SERVICE BULLETIN

NO. 0006 Page 1 of 4

SUBJECT: Fuel Selector Handle

MODELS AFFECTED: CC18-180A serial number 0001.

Figure 3 - Fuel Handle Installation

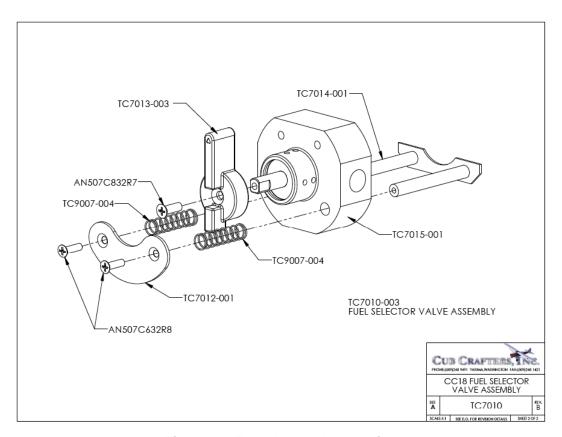
- 1. Remove fuel selector TC7013-001 by unscrewing the screw on the shaft of the handle.
- 2. Discard part number TC7013-001.
- 3. Install new fuel selector handle TC7013-003 by screwing it onto the shaft. (Figure 2 and Figure 3)
- 4. Rotate handle through all the positions and ensure that the detents are clearly felt when each tank position (LEFT, BOTH, RIGHT) are selected.
